KENWOOD

ASB-1007

Service Bulletin

Subject: TS-950SDX Speech Processor

**Signal Unit (X57-4130-00)
Foil Side View**

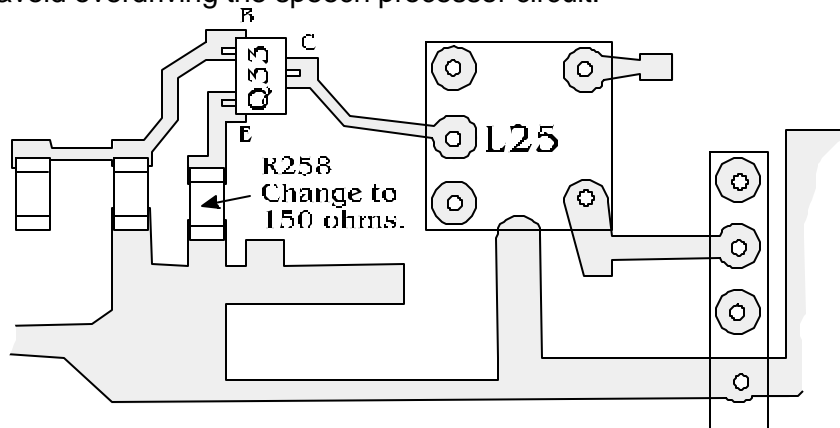
Reports of low **COMP** meter sensitivity, or noise on the transmitted audio when using the speech processor is normally a result of misadjustment of the **PROC IN** control. This control is very sensitive and is difficult to adjust properly.

Change the value of R258 in the SIG Unit (X57-4130-00) from 68 ohms to 150 ohms. This will increase the available adjustment range of the **PROC IN** control. This will make it much easier to properly adjust the control and thus avoid overdriving the speech processor circuit.

150 ohm chip resistor _____ Kenwood Part No: RK73FB2A151J
